UNITED STATES  
DEPARTMENT OF THE INTERIOR  
BUREAU OF LAND MANAGEMENT

FORM APPROVED  
OMB NO. 1004-0137  
Expires: January 31, 2018**SUNDRY NOTICES AND REPORTS ON WELLS**  
*Do not use this form for proposals to drill or to re-enter an abandoned well. Use form 3160-3 (APD) for such proposals.*5. Lease Serial No.  
NMLC064391B

☐ Oil Well ☒ Gas Well ☐ Other2. Name of Operator  
OXY USA WTP LPContact: DAVID STEWART  
E-Mail: david\_stewart@oxy.com8. Well Name and No.  
INDIAN HILLS UNIT 309. API Well No.  
30-015-316553a. Address  
P.O. BOX 50250  
MIDLAND, TX 797103b. Phone No. (include area code)  
NMLC 432-685-5717  
ARTESIA DISTRICT10. Field and Pool or Exploratory Area  
INDIAN BASIN MORROW

**Permanent Abandonment of Federal Wells  
Conditions of Approval**

OXY USA WTP LP - Current  
 Indian Hills Unit #30  
 API No. 30-015-31655

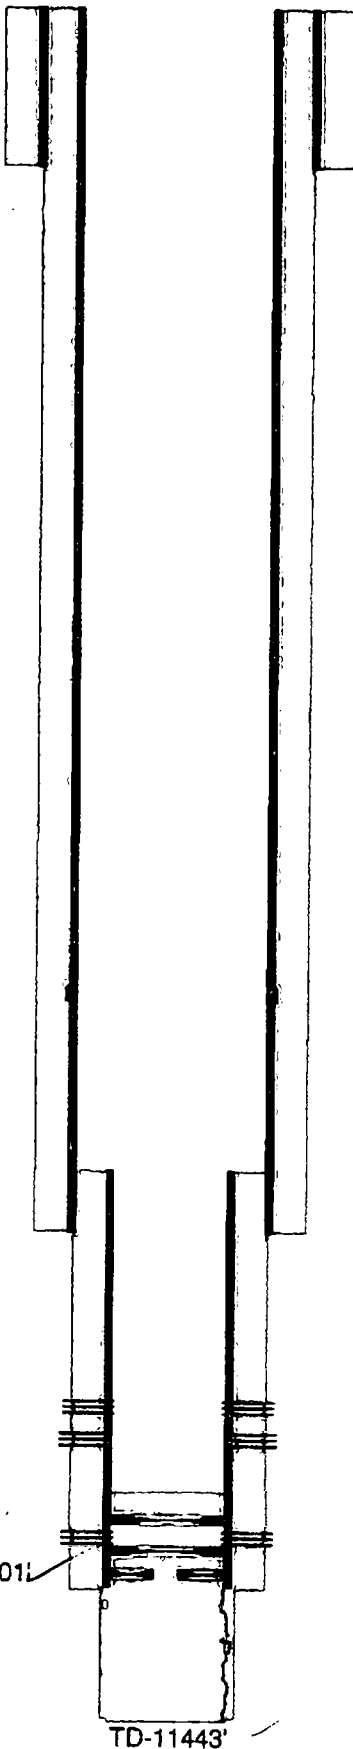
8543 (T/STRAWN & T/IRAN, Add plug from 7789-7609 (T/ISCO)  
6909 (T/WOLF CAMP & TUBB)  
2609-2352 (T/YASO & WORRETA)
